Re: Conversion of Two Project Area
Producing Wells To Injection
Service, South Caprock Queen Unit,
Chaves County, New Mexico (Case
2032, Orders R-1729 and R-1729-A).

SOUTH CAPROCK QUEEN UNIT
PROPOSED INJECTION WELL

Re: South Caprock Queen Unit
Application for Permission to Convert
Two Wells to Water Injection Service
Dated October 20, 1964

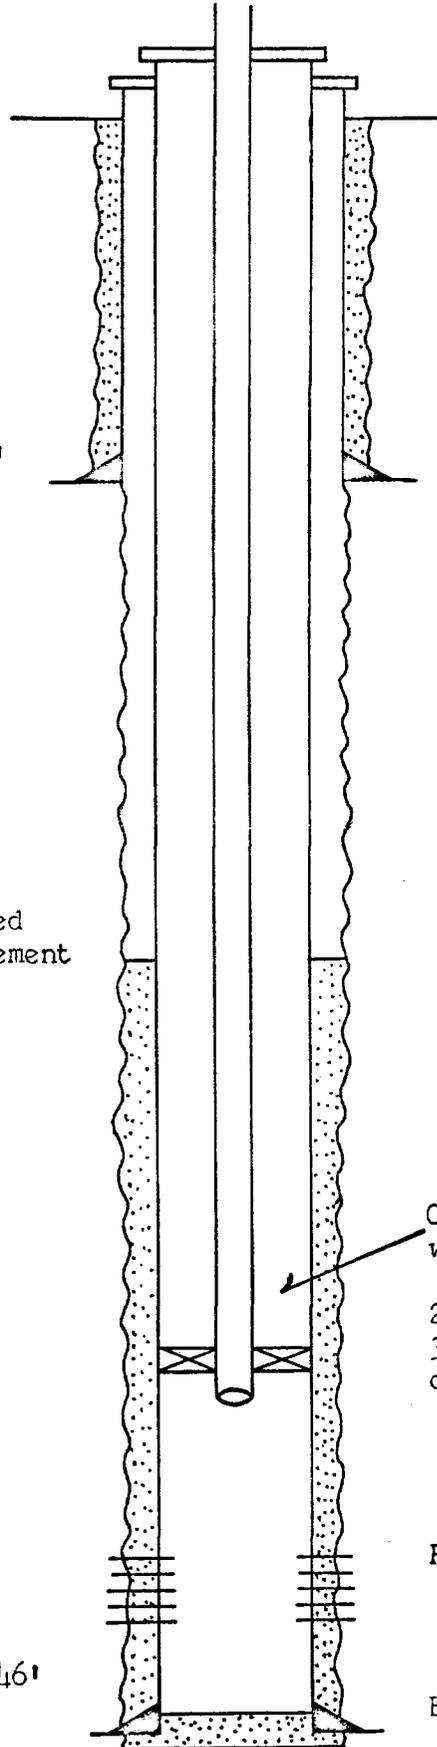
It is noted on Ex. IV that the cement used on the 5½ inch oil string was 625 sacks for well 13-5. It is noted on Ex. V that only 200 sacks of cement were used on the oil string.

Please advise the correct number of sacks of cement used on the 5½ inch oil string in this well.

Your letter dated November 12, 1964, regarding an error in the exhibits attached to our application for permission to convert two South Caprock Queen Unit producing wells to water injection service has been received. I have checked our files and find that Exhibit V, the diagrammatic sketch for Well No. 13-5, is in error. The 5 $\frac{1}{2}$ " oil string was cemented with 625 sacks of cement and the calculated top of the cement should be 760 feet.

In view of Mr. Butler's statement in his letter of November 17, 1964 concerning the number of sacks of cement and the calculated top used in setting the 5½" oil string, it appears that no threat of contamination to any fresh waters which may exist in the area will occur. Therefore, this office offers no objection to the granting of the application.
